City of Bay Minette

Planning Commission

AGENDA

February 9, 2023

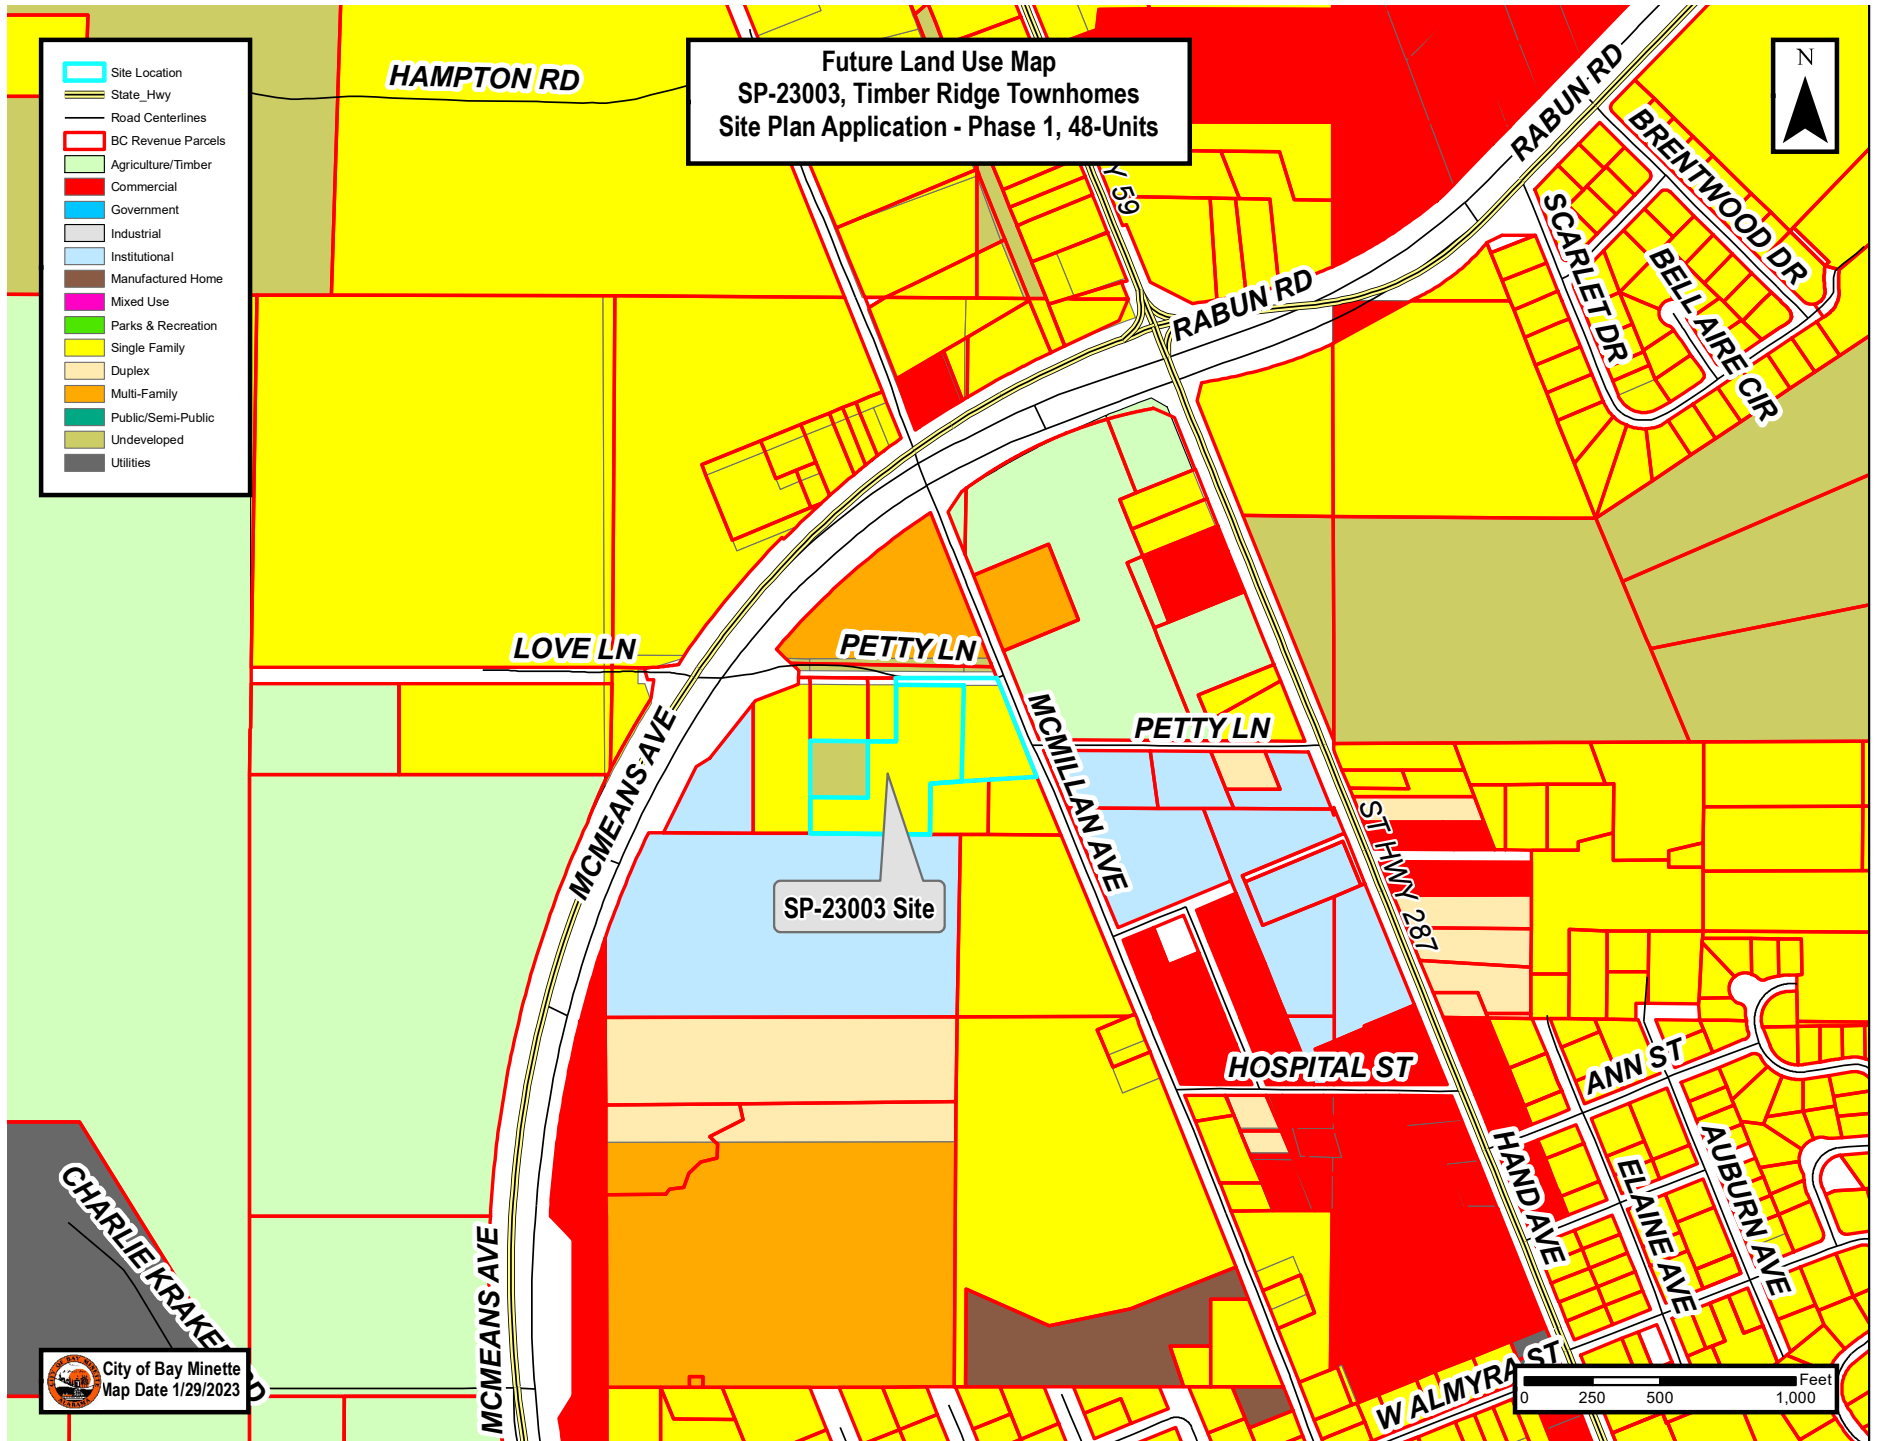
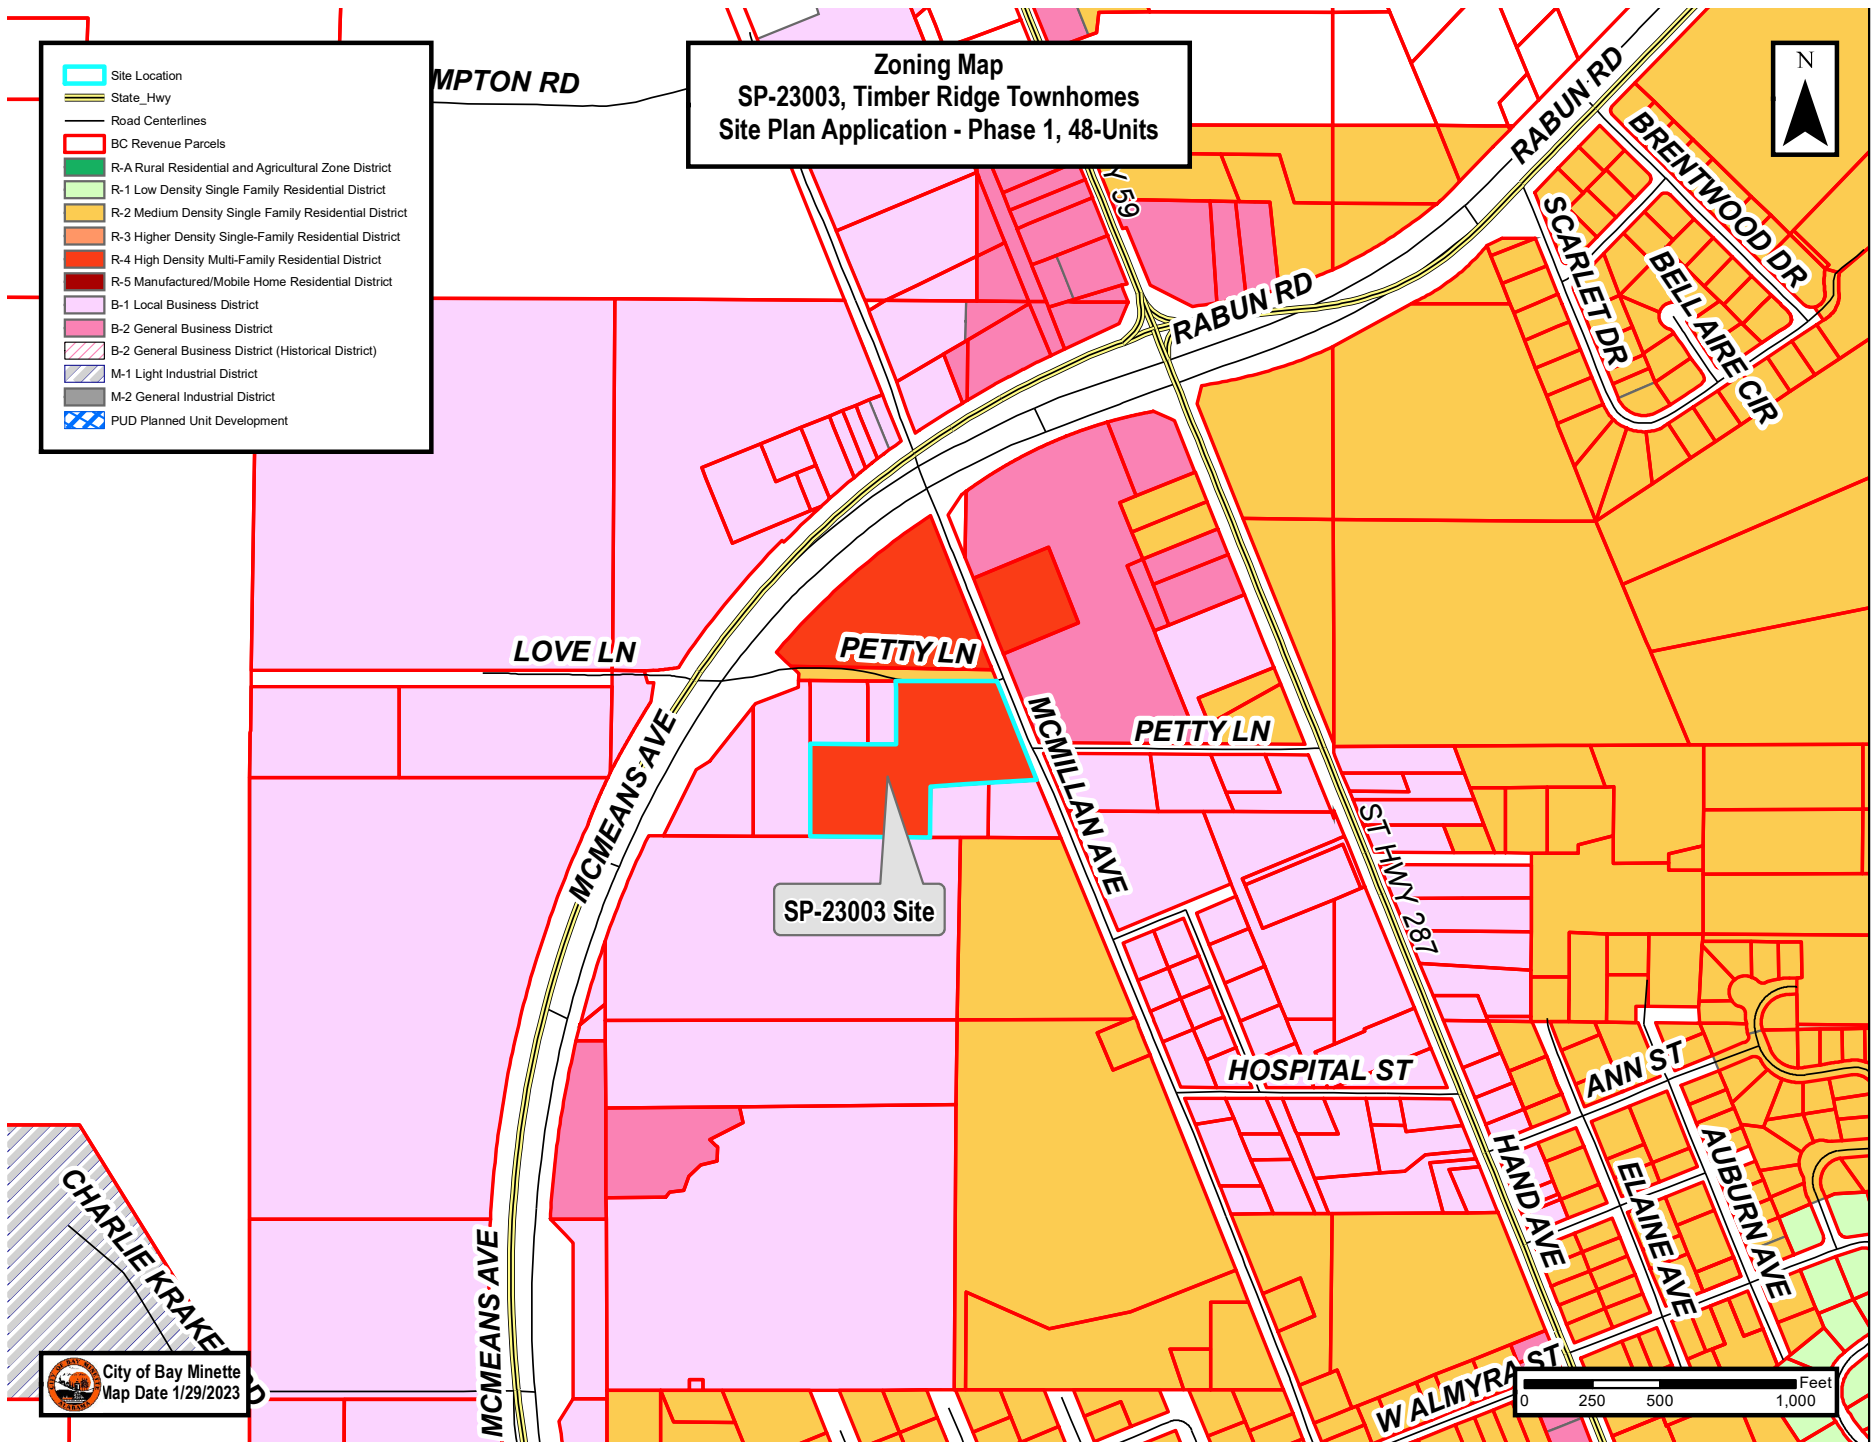
Baldwin County E-911 – Noted that the Site Plan labels Petty Ln as “New Petty Lane” and stated that this would need to be fixed to show just Petty Ln. Also noted that addressing plans for the site will require coordination between City Planning & Fire Dept staff with E-911.

McMillan is B-1, Local Business and B-2, General Commercial zoning. *Sec. 10.11.1* only requires a buffer zone “where a business district abuts any part of a residential district, a buffer zone 10 feet wide shall be required; where an industrial district abuts any part of a residential or business zone, a buffer zone of 20 feet shall be required.” A buffer zone would not be required for this development as it is based on adjacent zoning districts rather than use, however, the plans indicate an 8ft wood privacy fence along the entire length of the interior lot lines abutting the commercially zoned areas, as well as a significant landscaped buffer along the fencing. The proposed buffer exceeds the minimum requirements for a buffer design (*Sec 10.11.1*), which must be one of the three options: Wall or Fence, Screen Planting Strip or Natural Forest. The proposed buffer offers two of the three designs and exceeds those specific minimum design requirements as well.

The 8-ft fence proposed exceeds the 7-ft maximum height for fencing in residential areas (*Sec 7.16.5.2*), however, *Sec 10.12* does authorize the Planning Commission to impose additional standards/more stringent designs related to landscape standards that may ensure compatibility with surrounding properties and benefit aesthetics.

Off-Street Parking: Multi-family residential development requires 1.5 spaces for each unit. Approximately 144 parking spaces would be required and approximately 206 parking spaces, 10'x20', are provided per the plans. Parking spaces and sidewalk accessibility must be provided in accordance with the Americans with Disabilities Act, which will be evaluated in the building permitting/inspection phase of development.

Transportation: The applicant has revised the original site plan to meet the recommendations and minimum requirements of the City Transportation Engineer, which included a recommendation for a sidewalk on the west side of McMillan or a minimum, the developer should provide access to the existing sidewalk on the east side of McMillan and construct a crosswalk across the street at an appropriate location. The revised plans show three crosswalks (one on Petty Lane and two on McMillan) and sidewalks along the northern property line adjacent to Petty Lane. Internal sidewalks are also provided for the development.

The applicant submit the following plans for review and approval prior to the issuance of a Building Permit:

- 1.) Grading, drainage, utility and life-safety plans for review and approval by the Building Official, Fire Inspector and City Engineers.
- 2.) Plans satisfying the provisions for the disposition of open space and off-street parking landscaping provisions, prior to the issuance of a building permit.
